COMMENTS ON THE DOCUMENT TITLED
"Preliminary Seismic Survey of the Livingston LIGO Site"
WRITTEN BY Warren Johnson, Donald Stevenson and Kyle Clevenger
AND
RECOMMENDATIONS ABOUT THE LIVINGSTON SITE

WRITTEN BY: Yekta Gürsel, Fred Raab, Peter Saulson, Robert Spero

November 11, 1988

Preliminary Seismic Survey of the Livingston LIGO Site

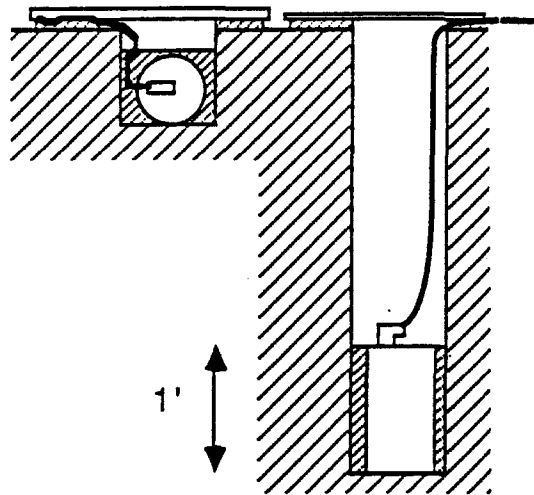
On page 5 of the document, the authors alter the instrument response function by multiplying it by a single pole high frequency roll-off function to fit the observed behavior. They state that the correction for the amplifier roll-off was not included because it made the fit worse. The amplifier roll-off should be included. If the fit got worse, this means the model for the given behavior was inaccurate.
